Intersection ID: 17851	Main Street: SCALEYBARK_RD	Cross Street: BROOKRUN_DR	Location:	NW
ADA ID: CBF8F94463EA	Ramp Type: ParaDiag	Initial Pass/Fail: Pass	Overall Compliance: No	Severity Score: 0

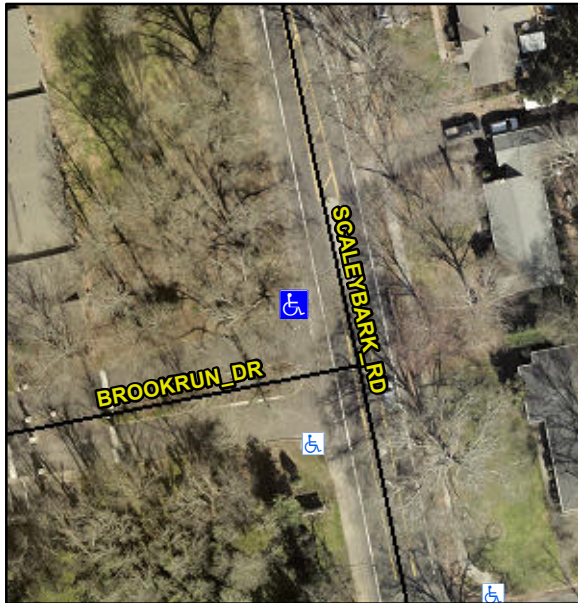
R304.2.1, R304.5.3

Compliance		Description	Data	Compliance		Description	Data
N/A		Ramp Length LT (in)	N/A	N/A		Ramp Length RT (in)	49.0
N/A		Ramp Width LT (in)	N/A	Yes		Ramp Width RT (in)	59.0
N/A		Ramp Slope LT (%)	N/A	Yes		Ramp Slope RT (%)	7.0
N/A		Ramp XSlope LT (%)	N/A	Yes		Ramp XSlope RT (%)	0.8
No		Landing Length (in)	58.0	Yes		DWS Provided?	Yes
Yes		Landing Width (in)	48.0	Yes		DWS Contrast?	Yes
Yes		Landing Slope (%)	0.6	Yes		DWS Length (in)	24.5
No		Landing X Slope (%)	3.6	Yes		DWS Full Width?	Yes
N/A		Landing Curb? (Y/N)	Yes	Yes		DWS Offset (in)	2.0
N/A		Shared Landing?	No				
Yes		Gutter Ponding?	No	Yes		Gutter Slope (%)	4.6
Yes		Gutter Lip Ht (in)	0.0	No		Gutter X Slope (%)	2.7
N/A		Painted X Walk1?	No	N/A		Painted X Walk2?	No
		X Walk 1 Direction	To S			X Walk 2 Direction	To E
N/A		X Walk 1 Width (in)	N/A	N/A		X Walk 2 Width (in)	N/A
		X Walk 1 Slope (%)	1.3			X Walk 2 Slope (%)	4.3
		X Walk 1 X Slope (%)	2.3			X Walk 2 X Slope (%)	1.1

Remove & Replace Curb Ramp With Two New Directional Ramps or Equivalent. Remove & Replace Gutter.
